UNITED STATES PATENT AND TRADEMARK OFFICE

Office Action Summary

10/815,993

DETAILED ACTION

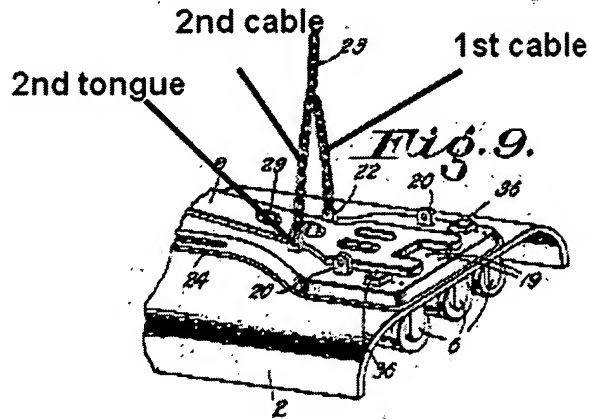
With respect to claims 1 and 3 Kilduff et al. teaches a lighting fixture (fig 9), comprising a housing 1 supporting a first lamp 6 including a wall 21 and an opening opposite the wall (Fig 11). Kilduff also teaches a first suspension cable 23 coupled with a housing. The cable includes opposite first and second ends (shown in Fig 1, not numbered) the first end of the suspension cable having a first loop (loop connecting to 22). Kilduff also teaches a first tongue 22 that is formed integrally therewith in the wall of the housing (Fig 11) that engages the loop of the cable (Fig 9), and a second tongue formed in the wall that has a second suspension cable that has a loop that engages the second tongue (as indicated below).
